<b>AMENDMENT OF SOLICITATION/MODIFICATION OF CONTRACT</b>			1. CONTRACT ID CODE	PAGE 1 OF 10 PAGES
2. AMENDMENT/MODIFICATION NO. AMENDMENT NO. 0002		3. EFFECTIVE DATE 01/19/12	4. REQUISITION/PURCHASE REQ. NO.	5. PROJECT NO. (If applicable) 11-0079
6. ISSUED BY CODE		jsy	7. ADMINISTERED BY (If other than Item 6) CODE See Item 6	
Officer in Charge of Construction MCI-East 1005 Michael Road Camp Lejeune, NC 28547-2521				
8. NAME AND ADDRESS OF CONTRACTOR (No., street, county, State and ZIP Code)			(X)	9A. AMENDMENT OF SOLICITATION NO. N40085-11-R-0079
			X	9B. DATED (SEE ITEM 11) 12/20/11
				10A. MODIFICATION OF CONTRACT/ORDER NO.
				10B. DATED (SEE ITEM 11)
CODE	FACILITY CODE

11-0079, Install Modular Buildings at Onslow Beach, Phase VI

**CONTINUATION SHEET**

**1 PILING LAYOUT/ FRAMING PLAN STANDARD**

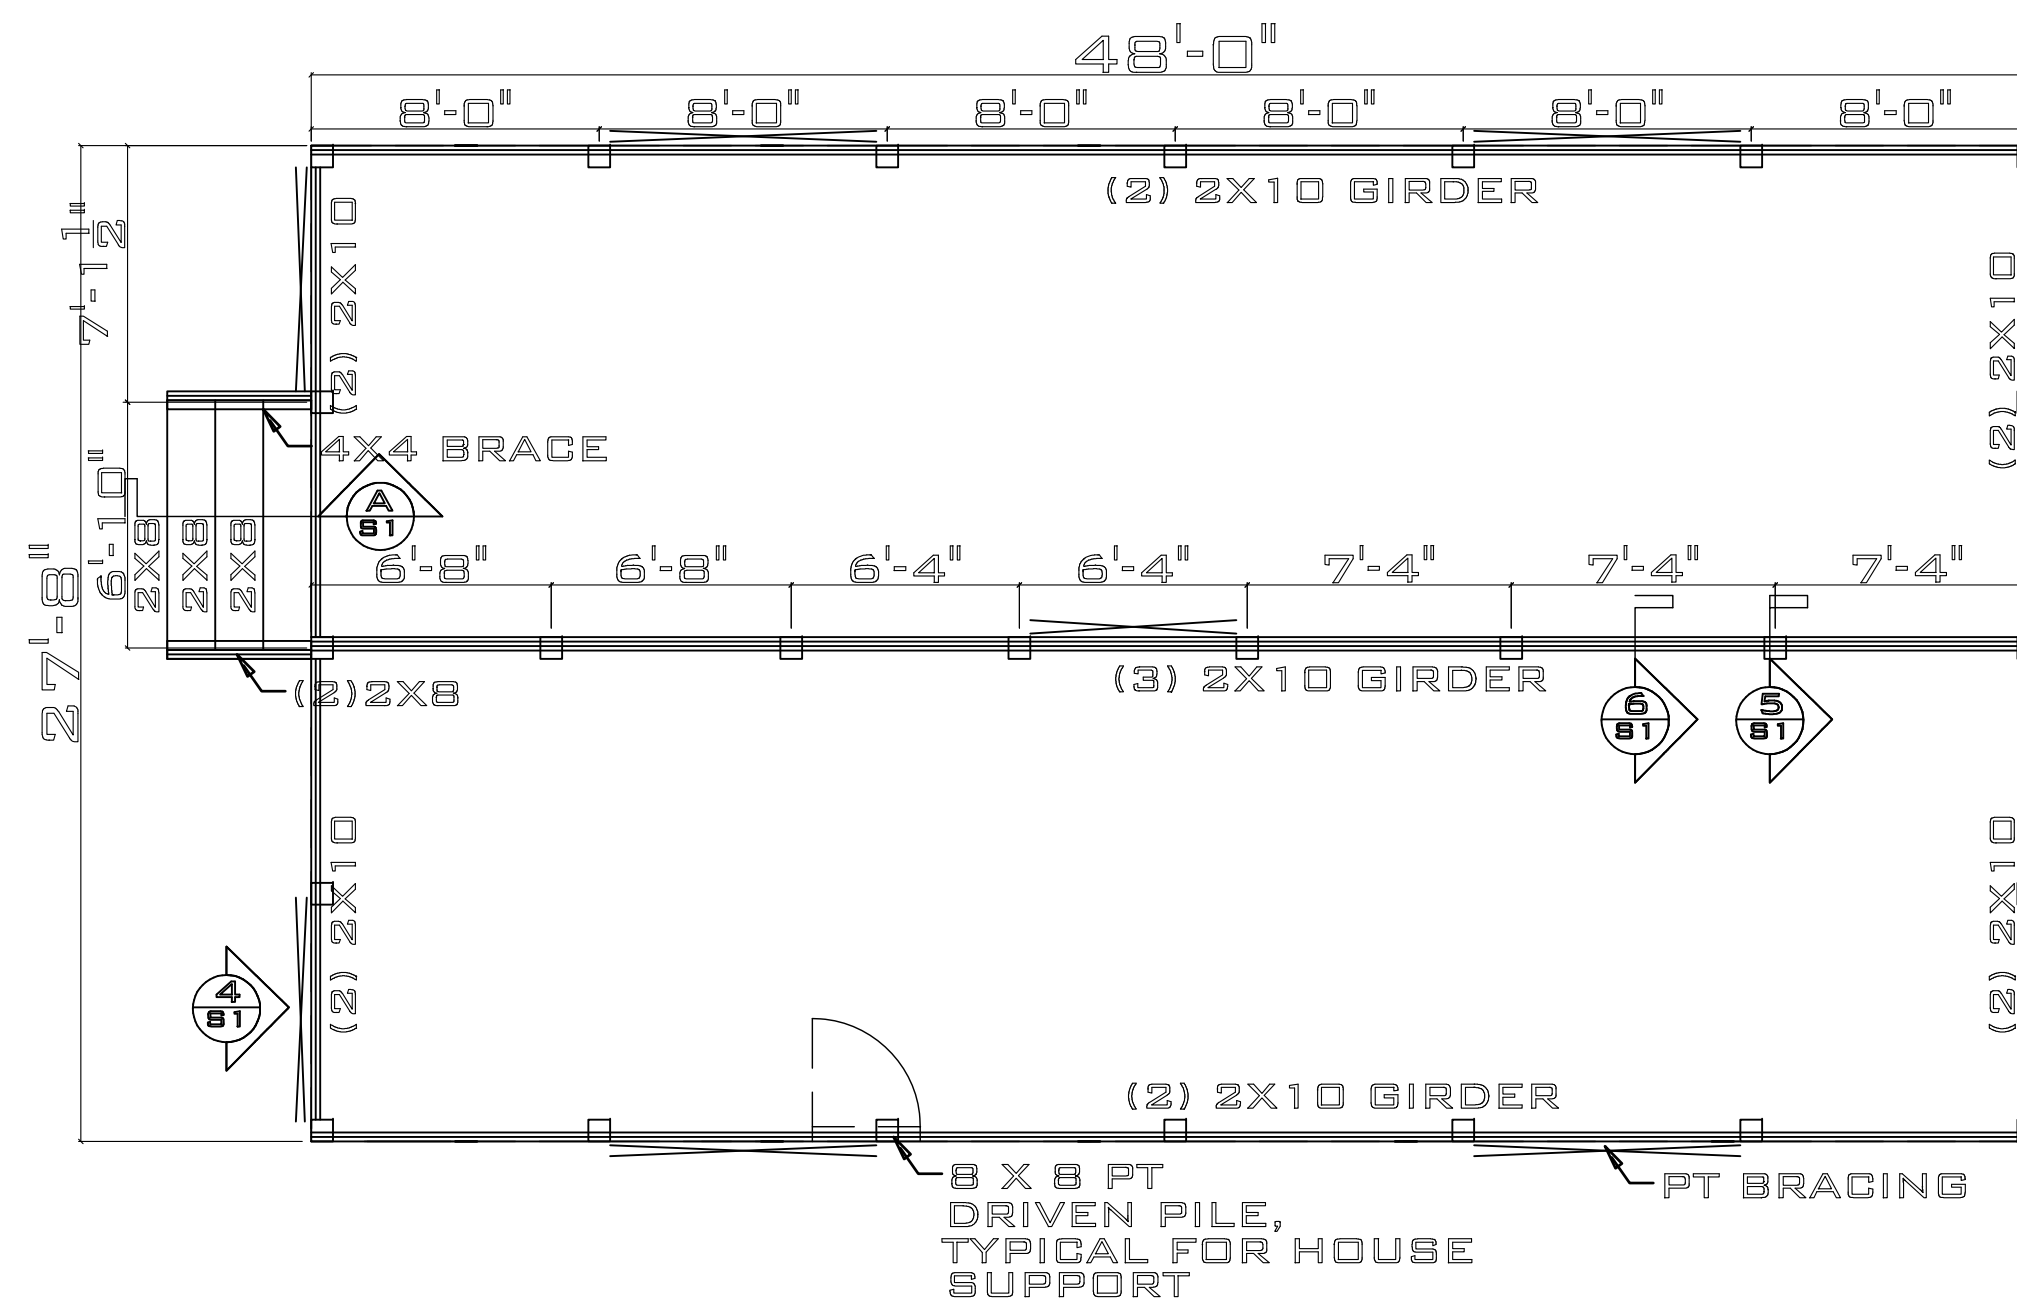
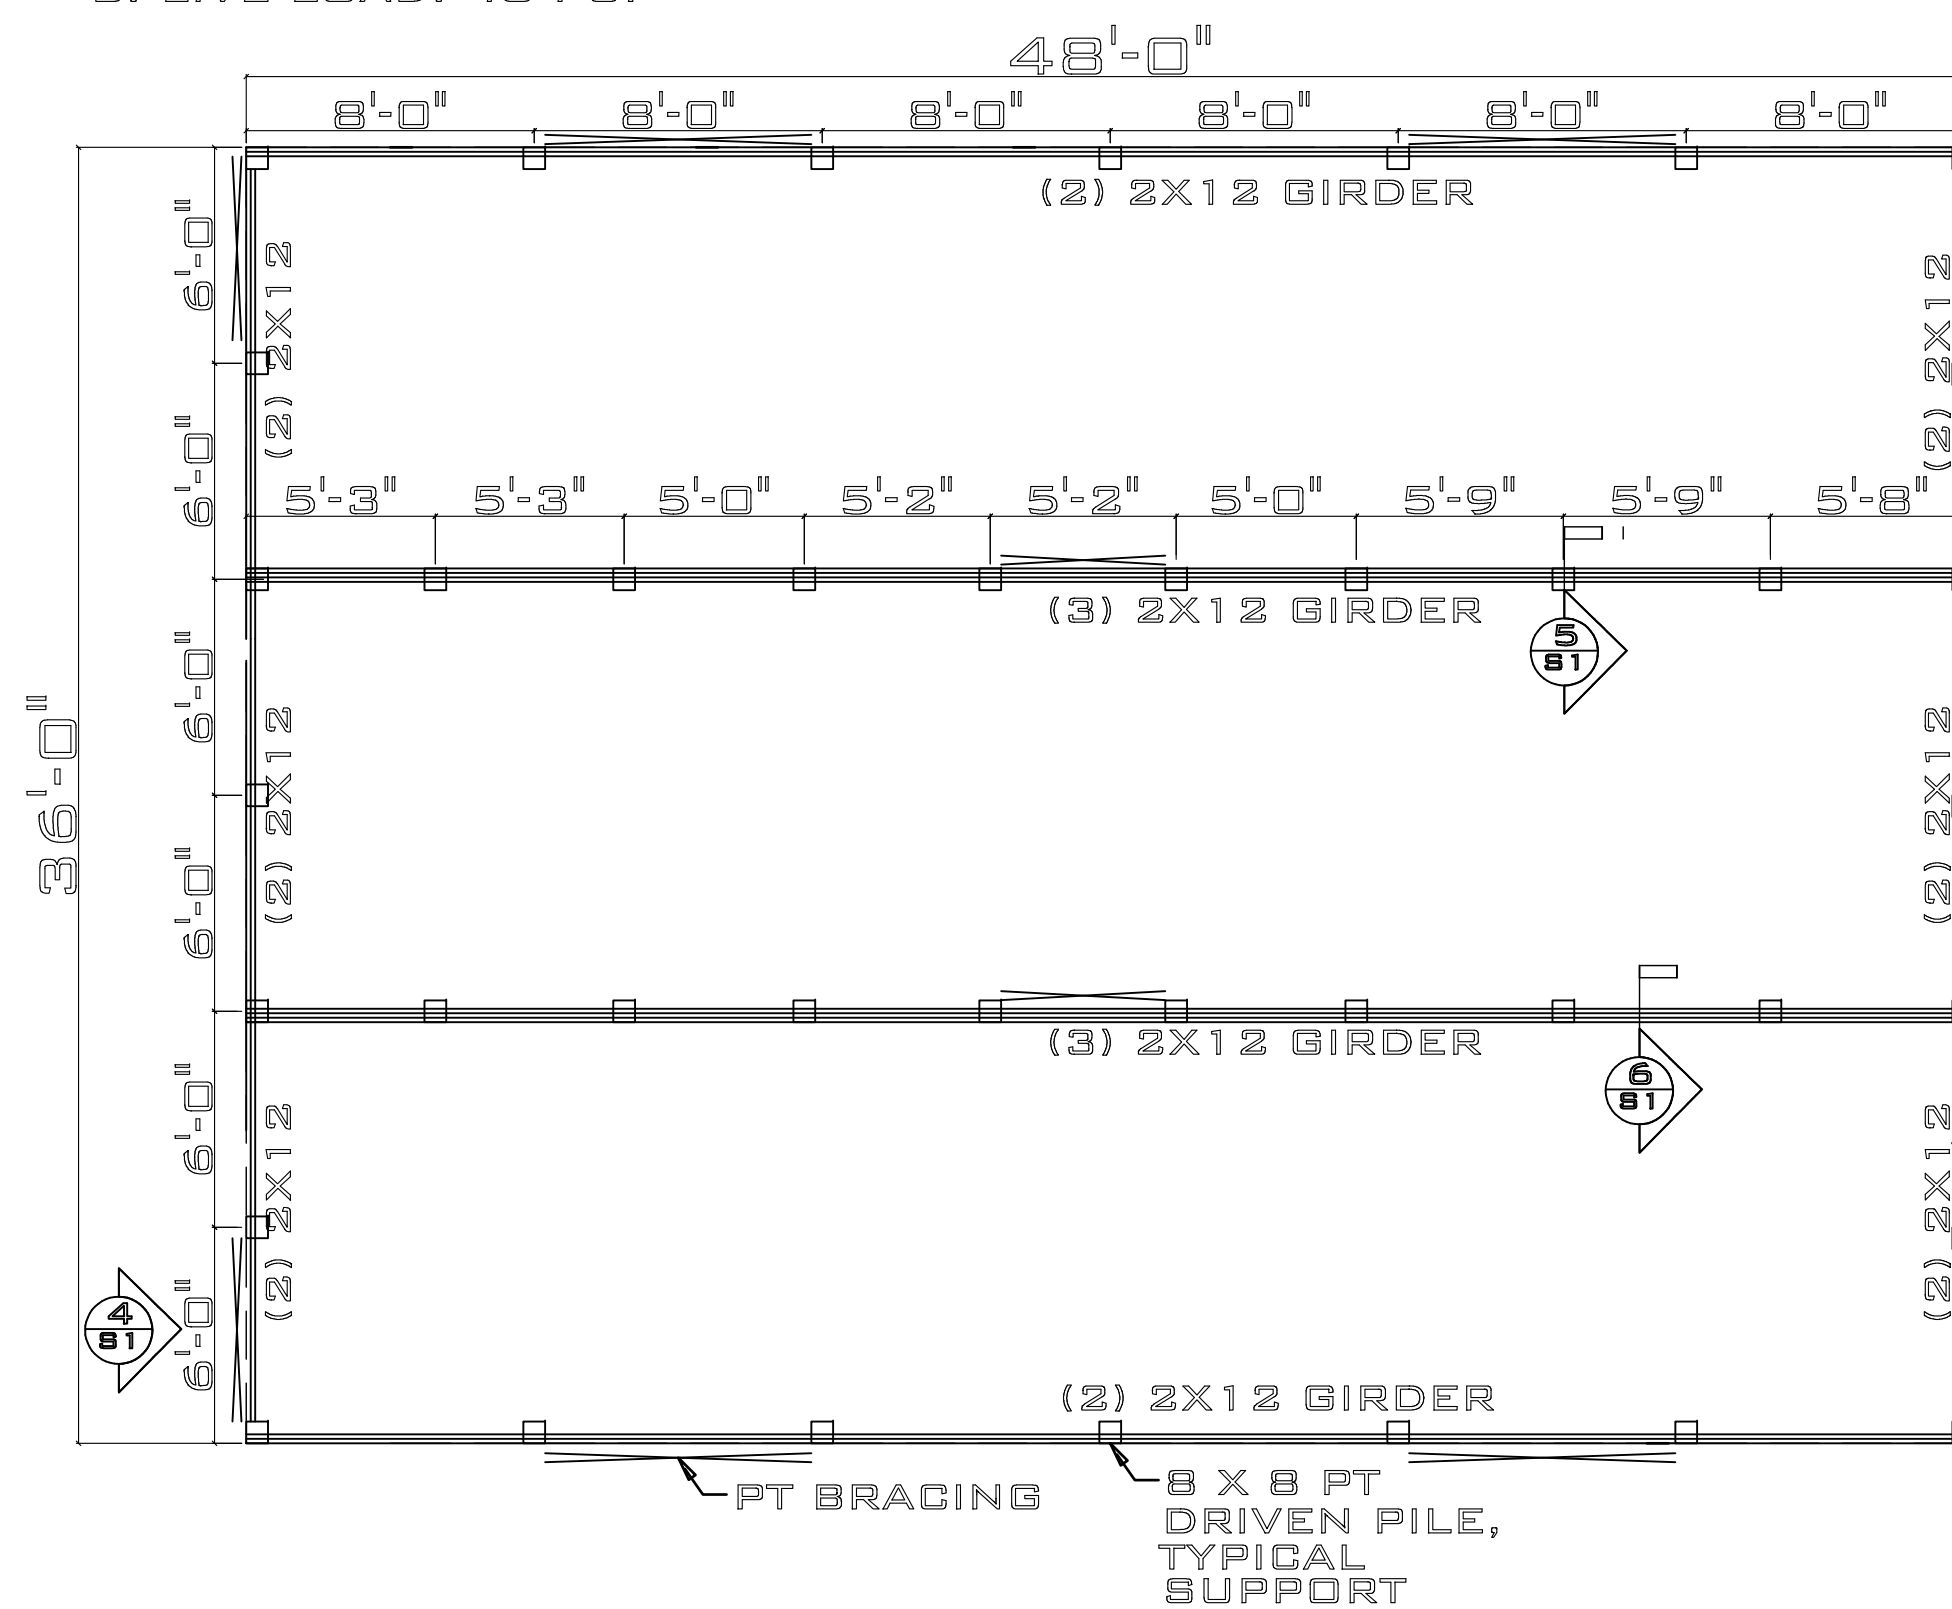
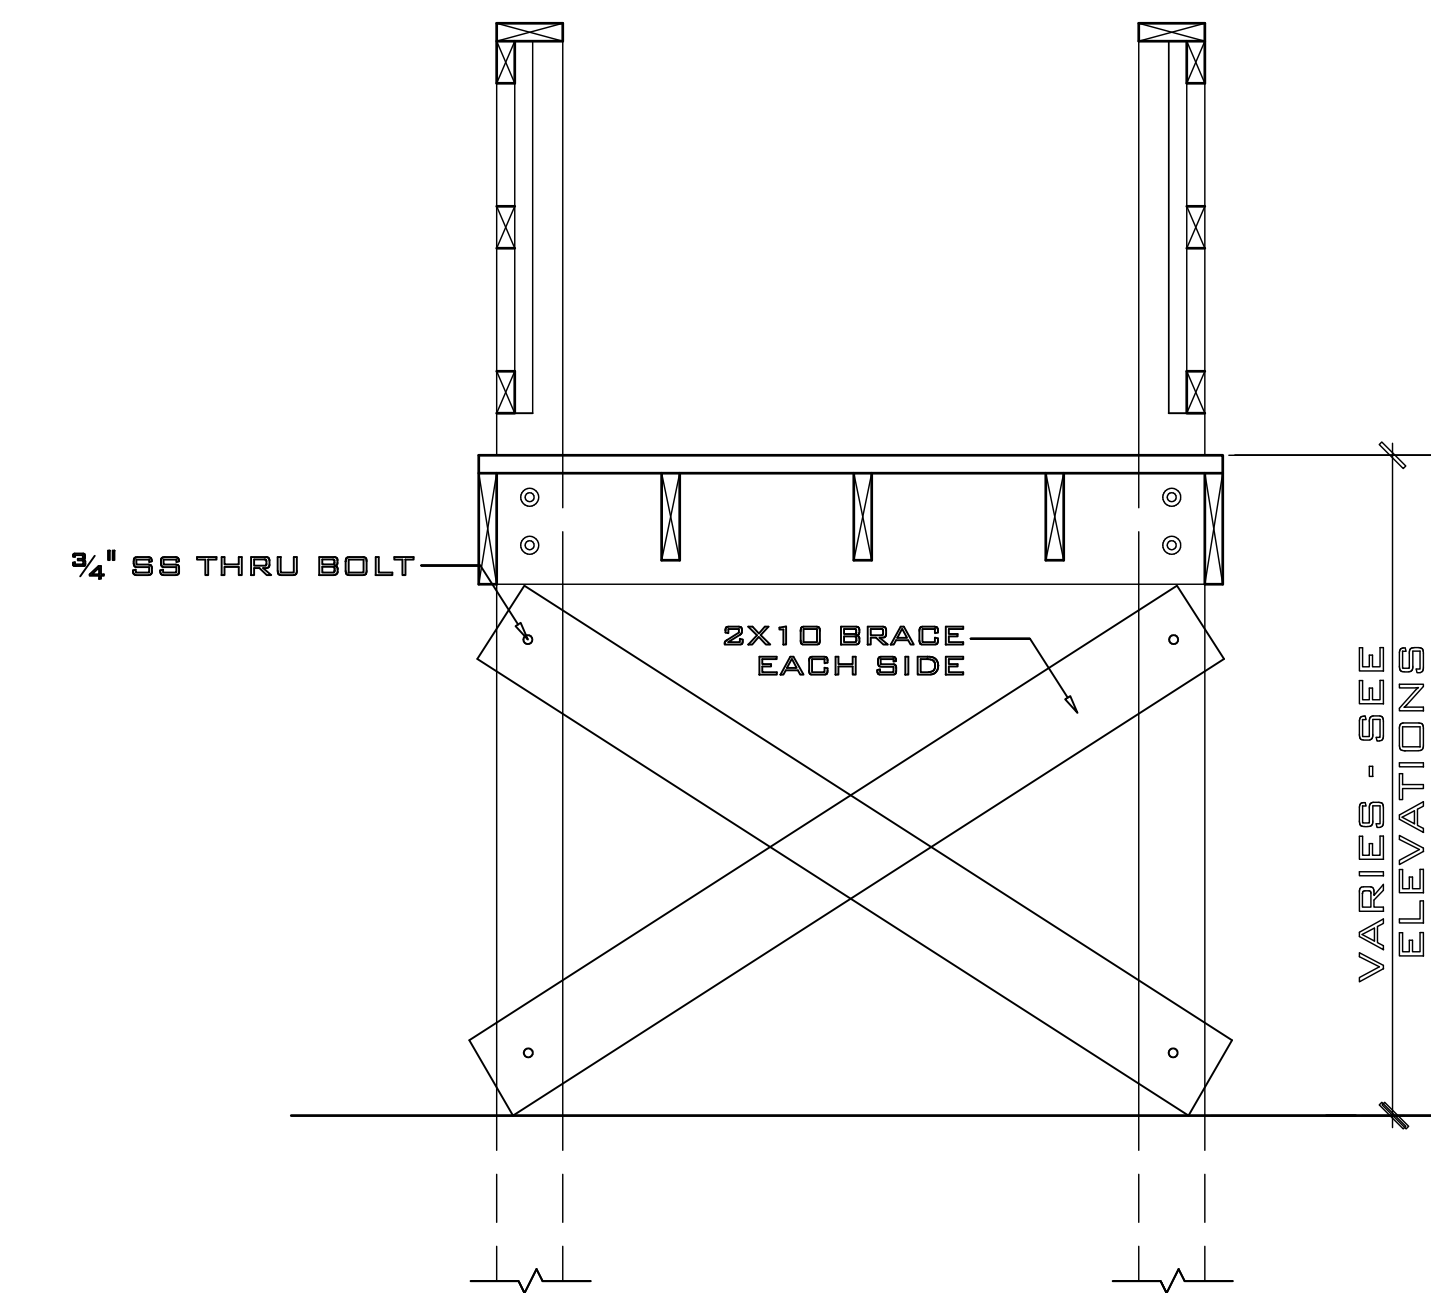
**6 Question:** With reference to sheet S1, confirm the joist framing indicated, 2x10 and 2x12 16" OC on details 2 and 3. These framing details differ significantly from previous phases 1 -4.

**13 Question:** Earlier phases of this work had the wood (3) 2x10 and (3) 2x12 Girders framed perpendicular to the main framing elements of the Modular Building. The details on this project have the girders running parallel, they will not directly support the modular building unit's main framing. Is the layout shown correct?

**14 Question:** If girder layout is confirmed as correct, is would appear that the 2 X 10 and 2 X 12 floor joists support the units. What size floor joists are required for the standard style units as none are indicated on the drawing.

**6 Answer:** Yes secondary substructure has been modified such that only it consists of the double girders on the perimeter and the triple girders interior bearing directly on the piles.

**14 Answer:** Floor joists shown are that of the modular unit. No additional joists are required.

**7 RAMP SECTION**  
**SCALE: 3/4" = 1' - 0"**

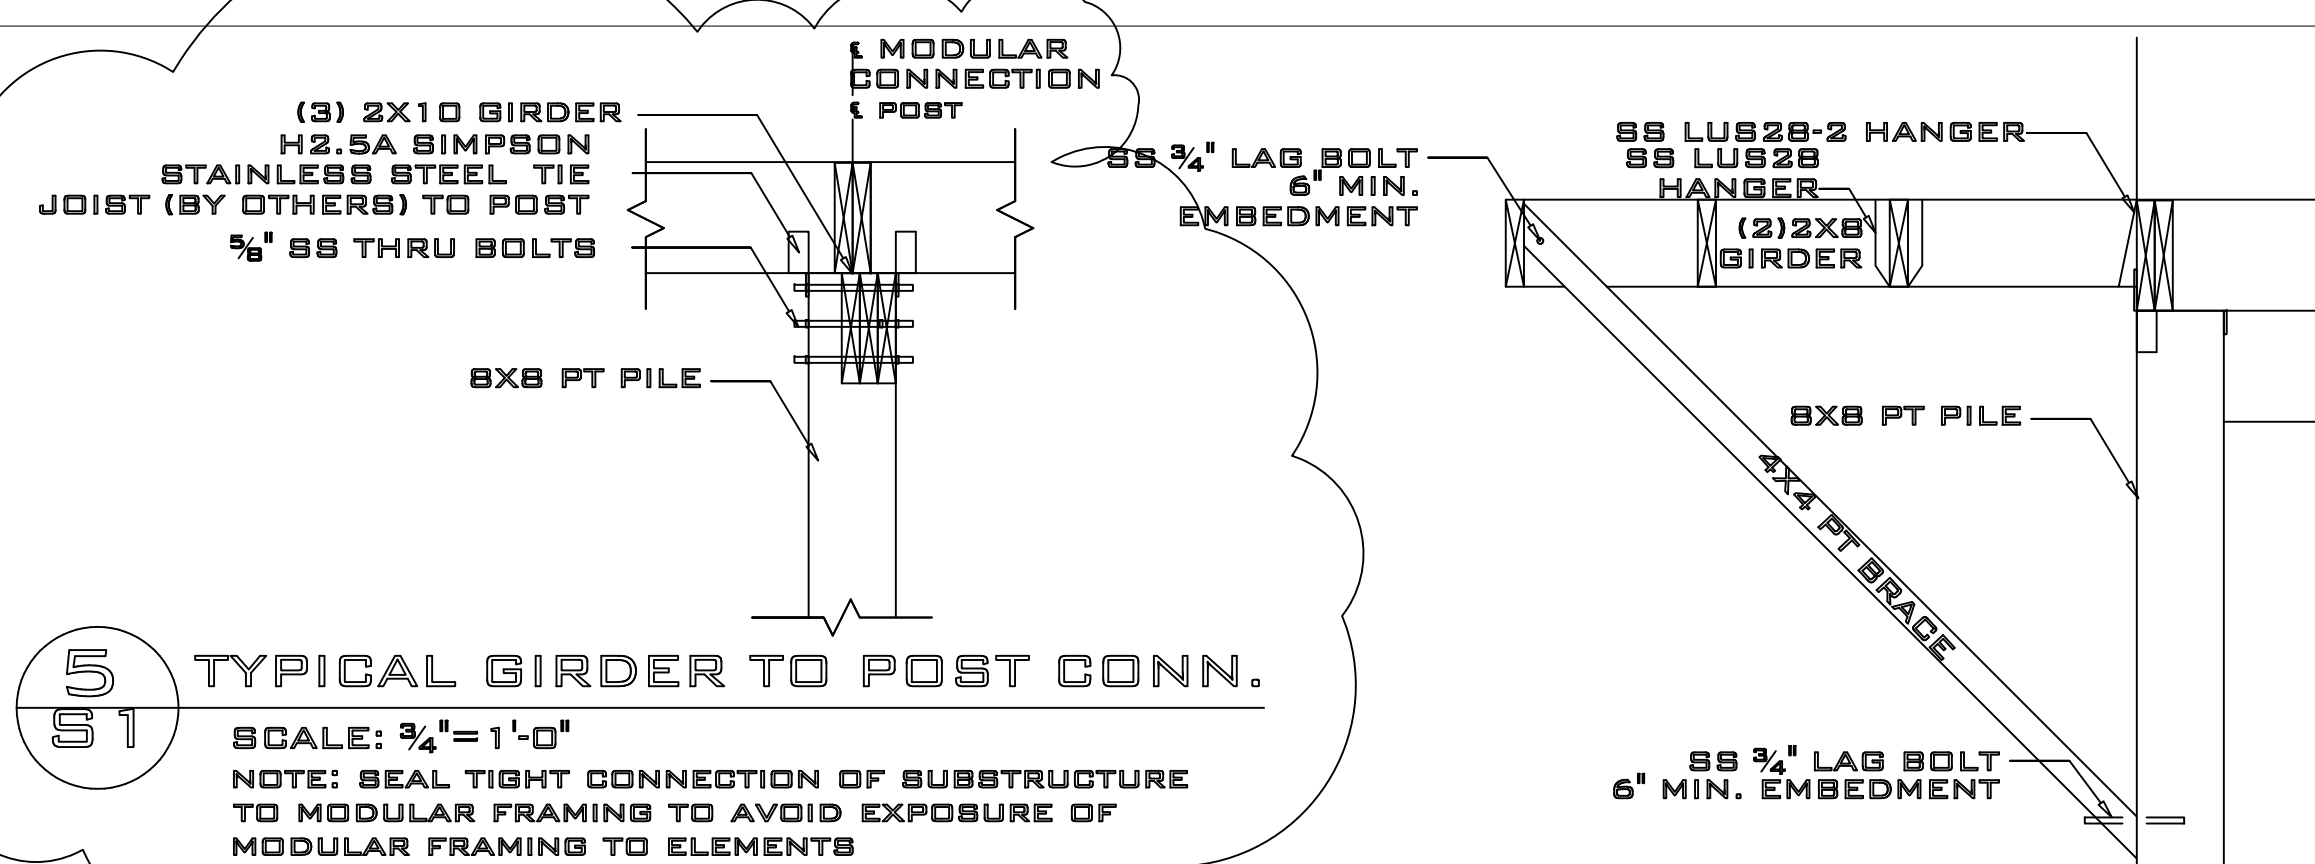
**27 Question:** What is the minimum penetration the pilings are to have?

**27 Answer:** 10' see 7/S1
